Figure 2-1 — MRY Unit 1 Existing System Mercury Removal Performance Capabilities using Brominated PAC

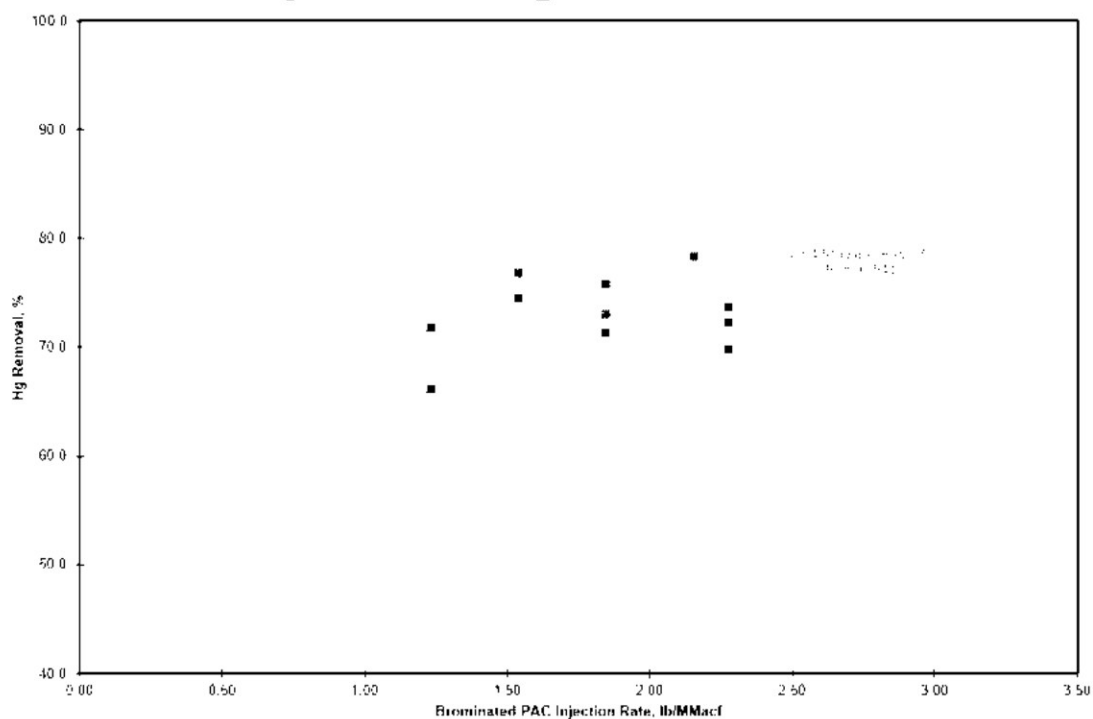
into MRY Unit 1 is not an adequate control strategy to achieve the New Mercury Limitation and that EPA ignored and erroneously omitted limitations of ACI in its achievability conclusion . **Attachment A**, at Figure 2-1. The scatterplot from the Report is presented below.

34. Mercury testing and analysis of data at MRY confirms and supports Minnkota’s belief that numerous variables affect its mercury emissions rate. Specifically, Minnkota observed mercury emissions rate fluctuations based on unit load, mercury content in lignite, and normal variability in unit operation and control equipment function. Some hourly
